MEMORANDUM

SUBJECT: SF-18-008 – Lorson Ranch East Filing No. 1
Response to Comments - First Submittal

Final Plat

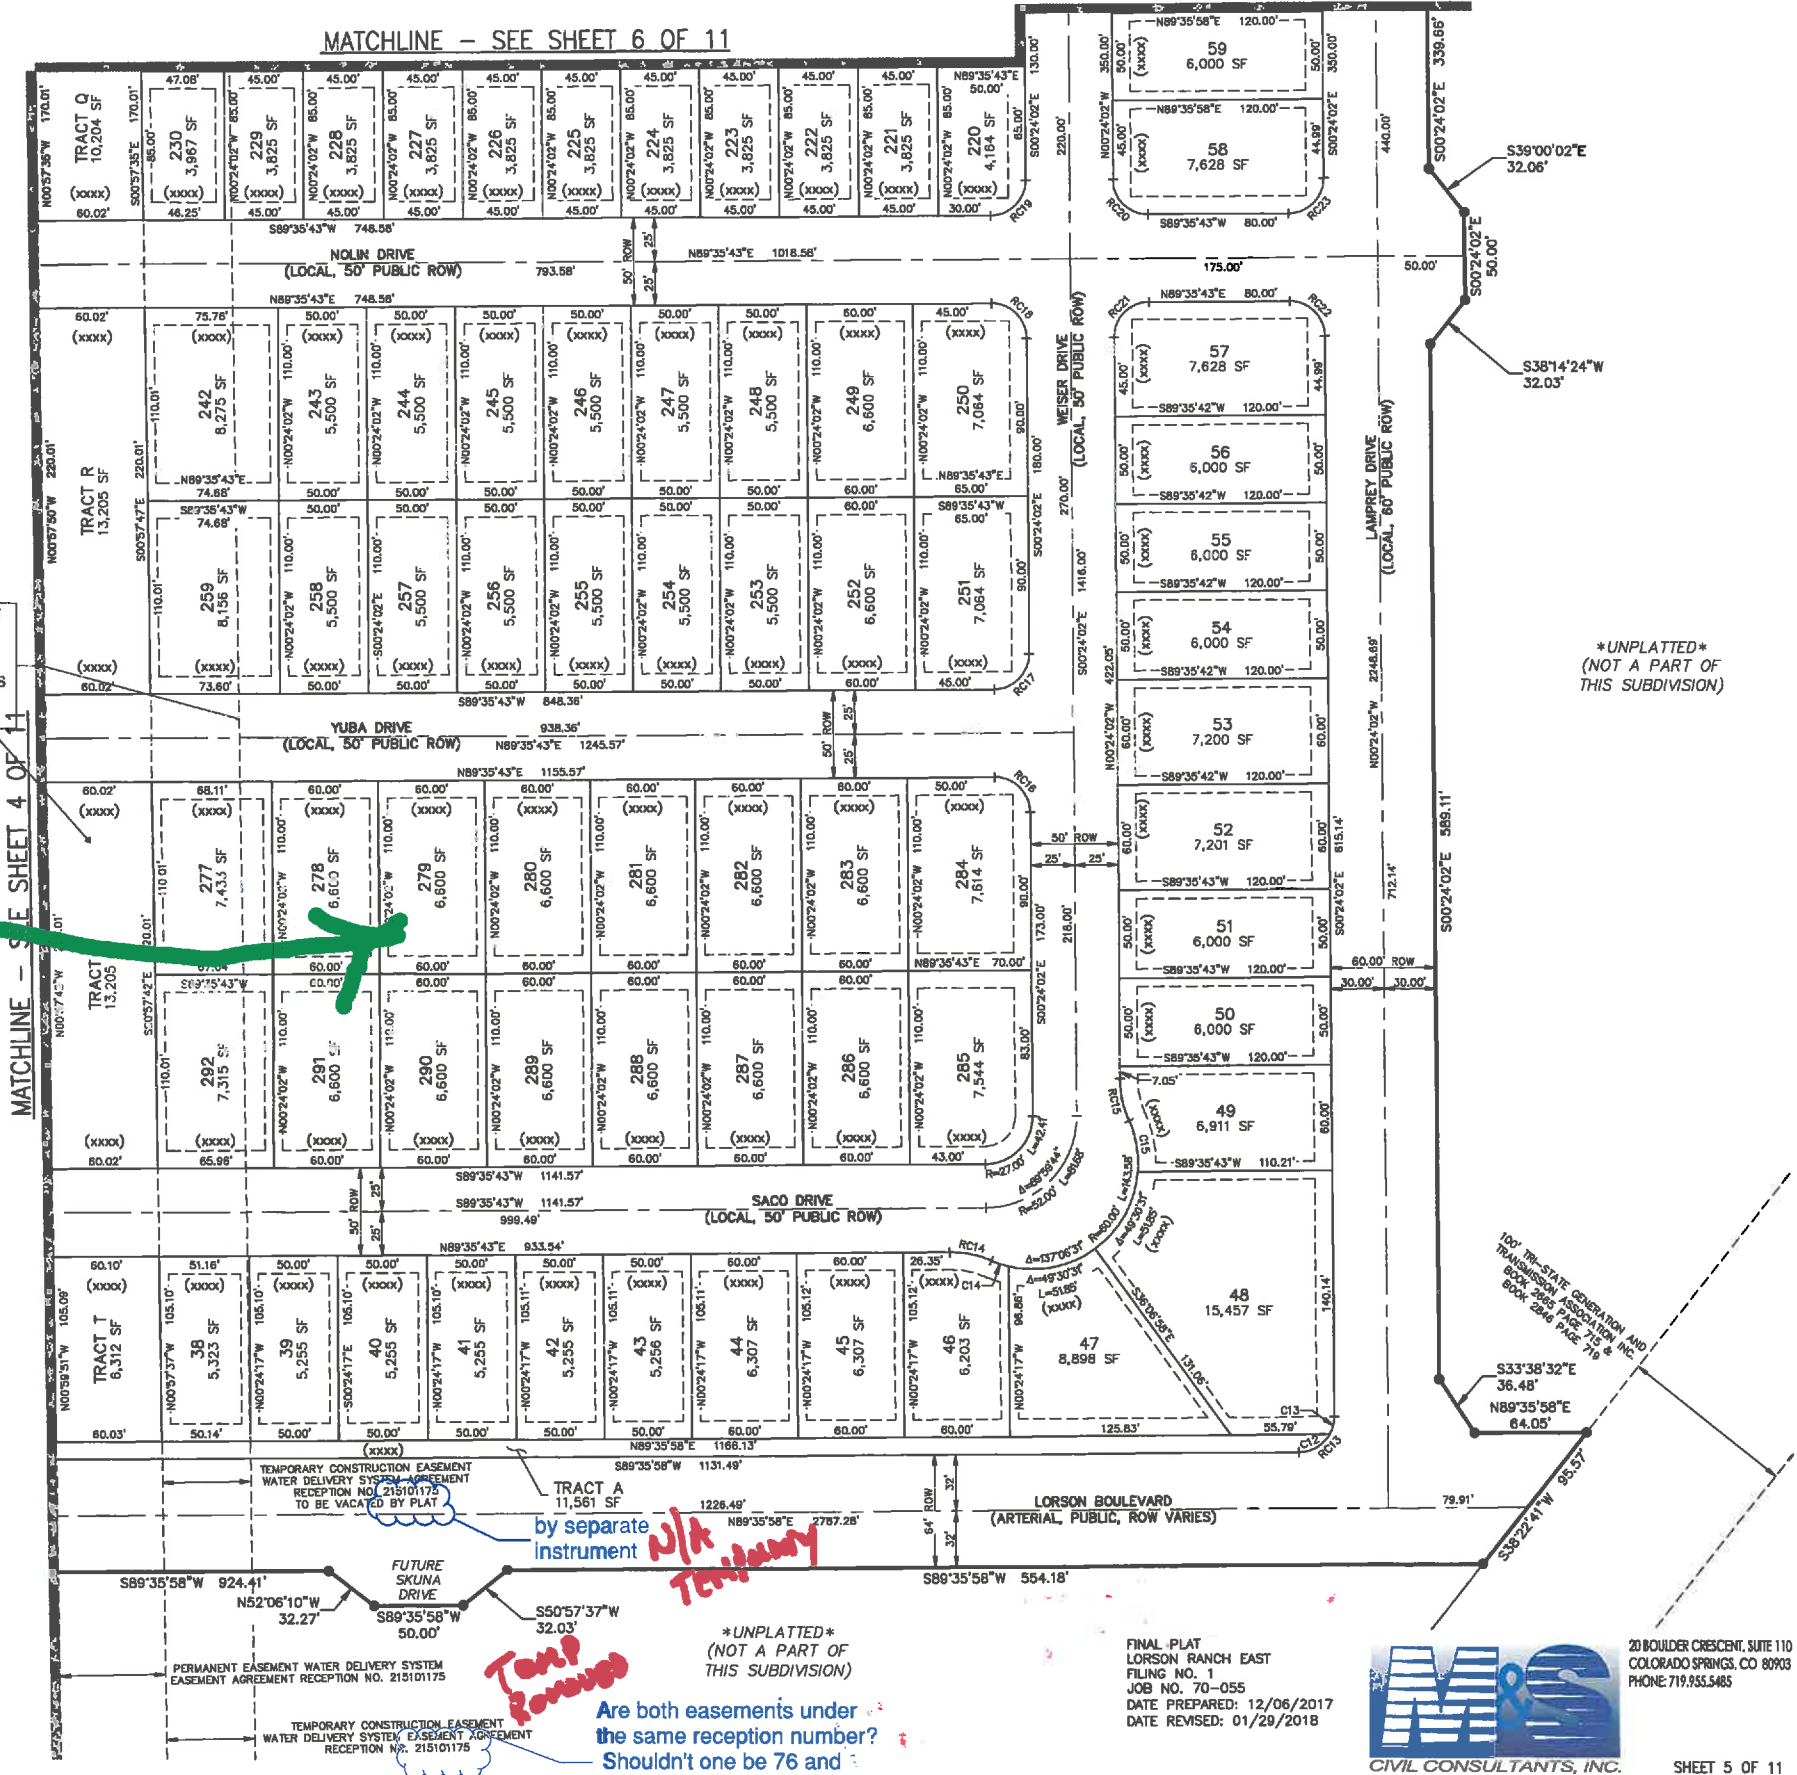
what are the dashed lines? Is this part of the SDS easement?
Please label the SDS easements in the tracts

where is this? I can't discern where the section of road is in relation to these lots

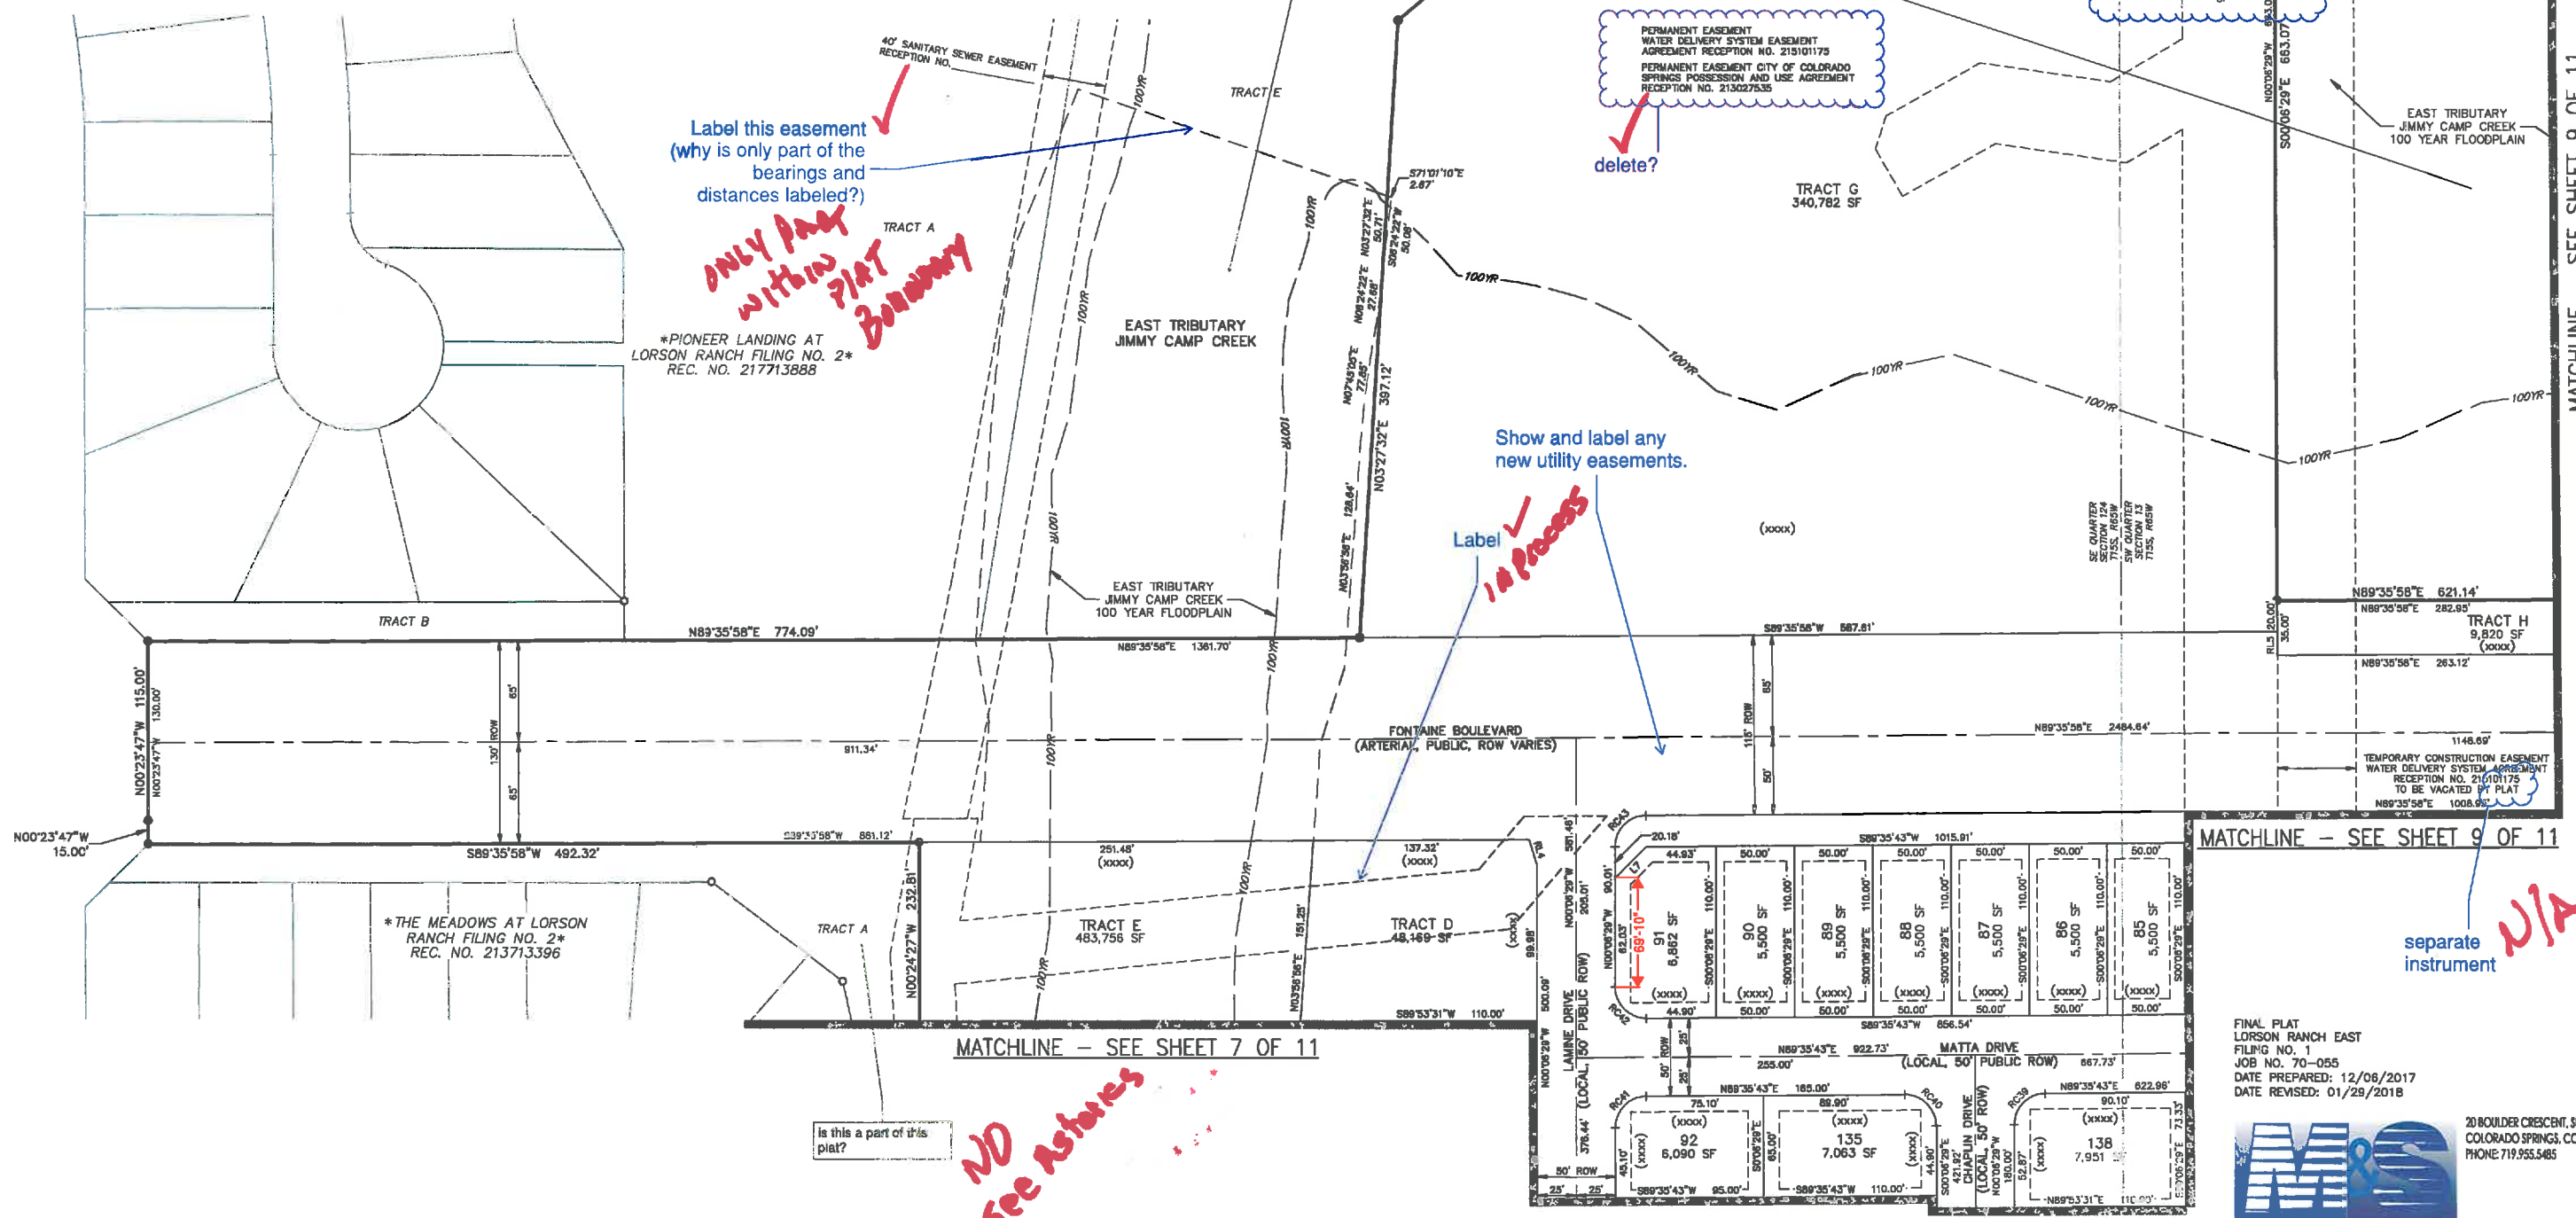
The line work is confusing. The floodplain arrows are not pointing to anything. If the channel is below how is it over to the east on the same page? It is hard to see what is being platted. Boundary line should be different than other lines through out the plat sheets.

Label this easement (why is only part of the bearings and distances labeled?)

Show and label any new utility easements.

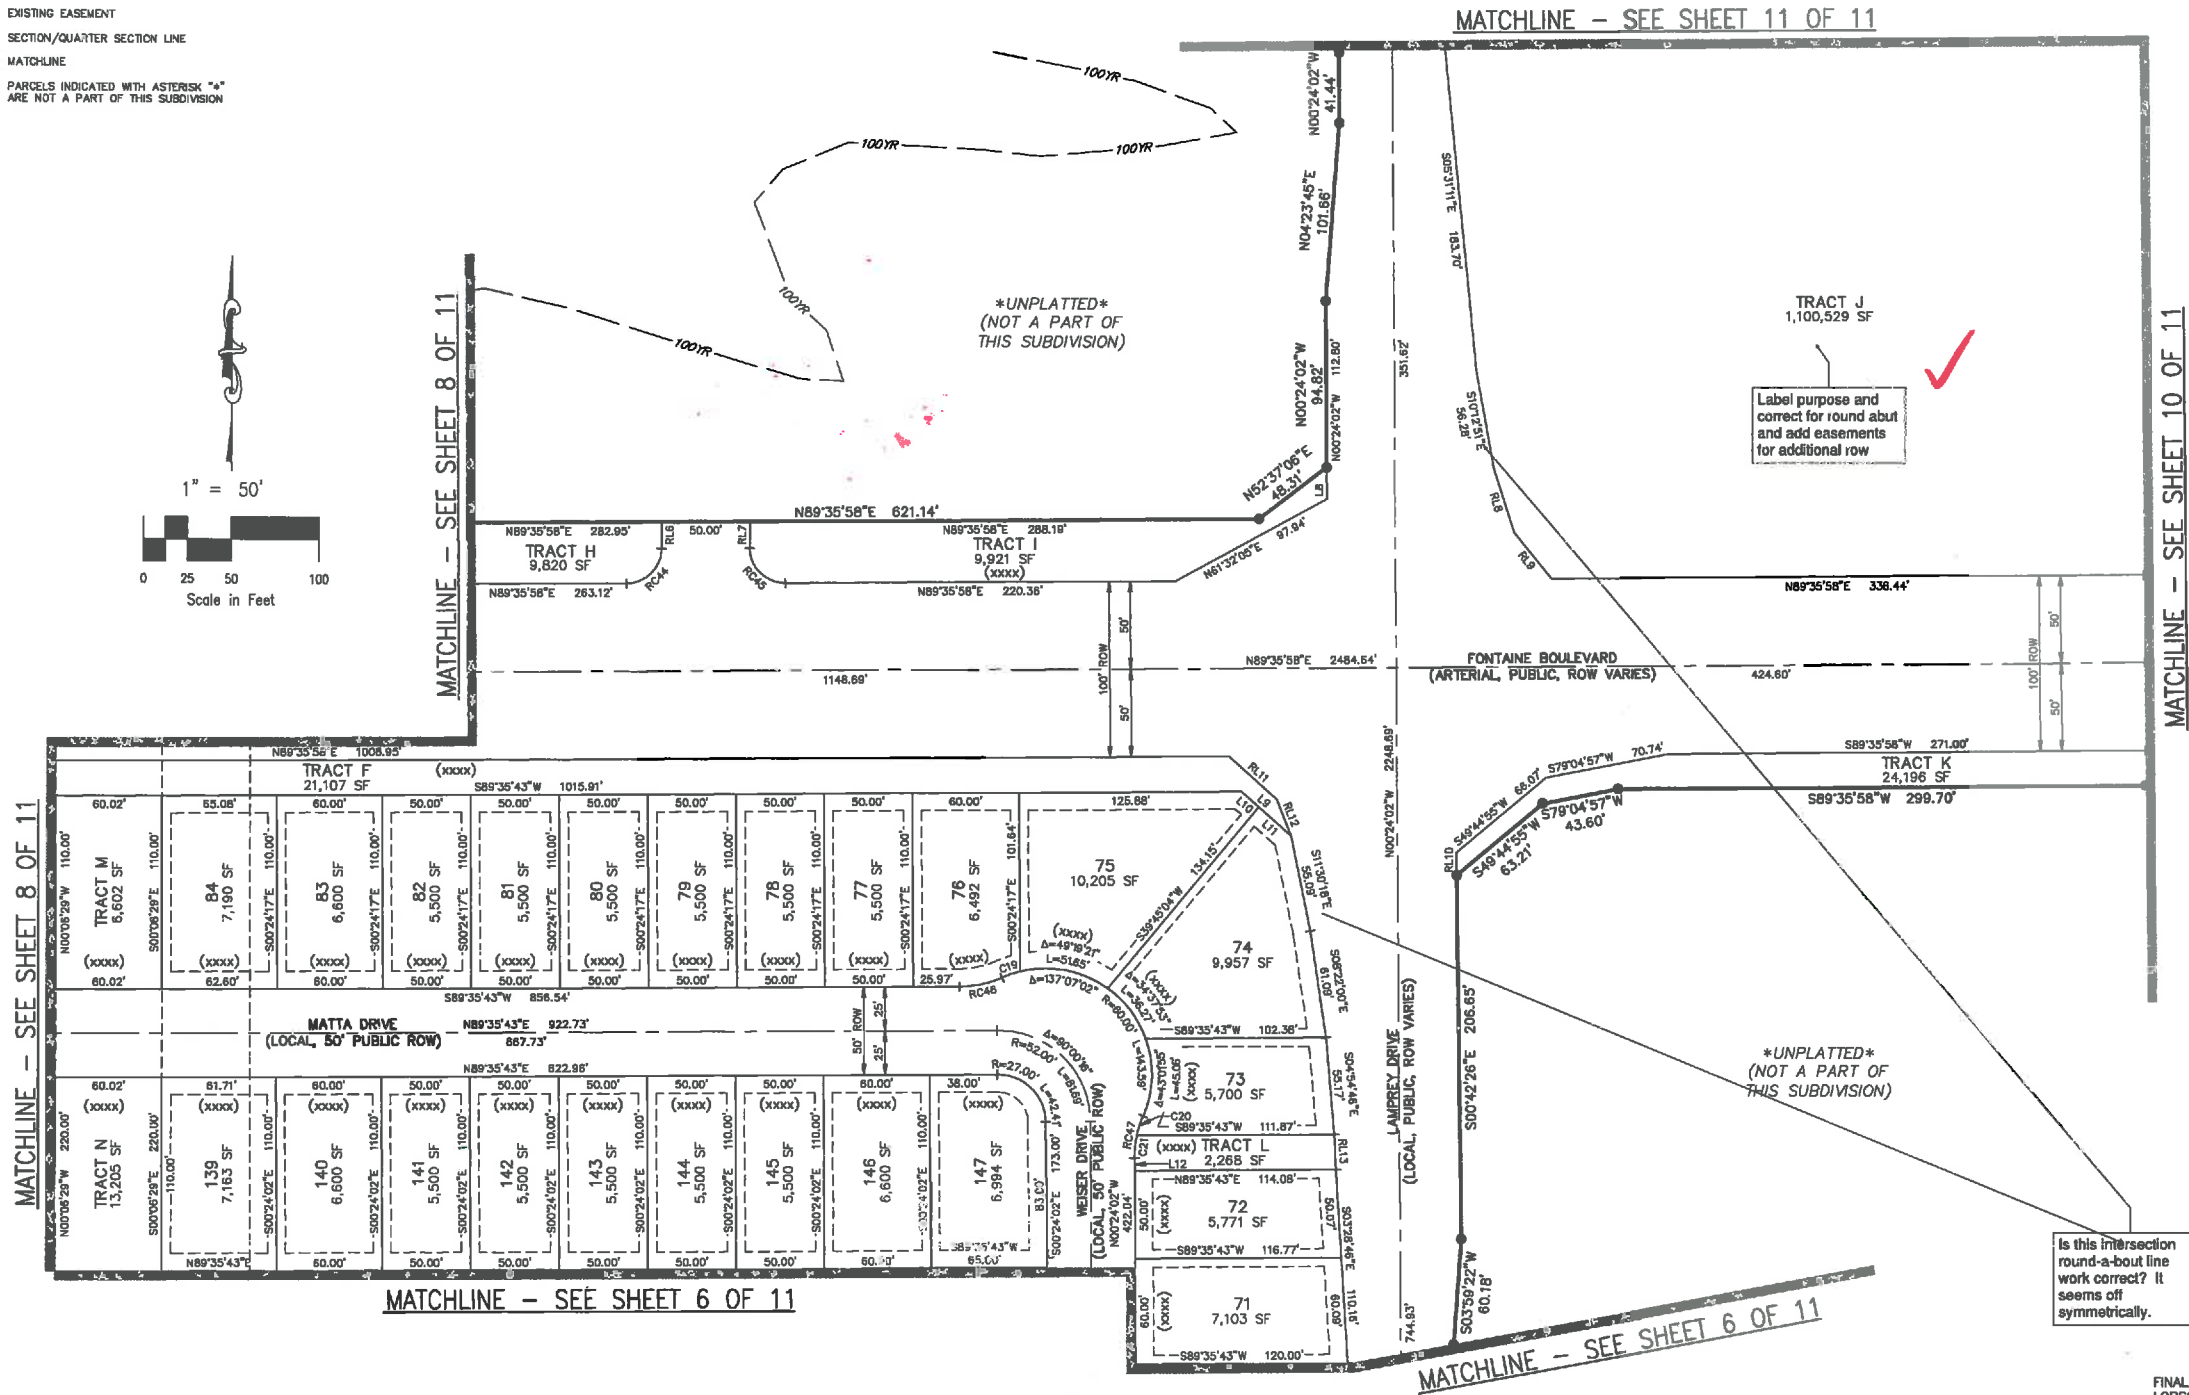
Label purpose and correct for round about and add easements for additional row

Is this intersection round-a-bout line work correct? It seems off symmetrically.
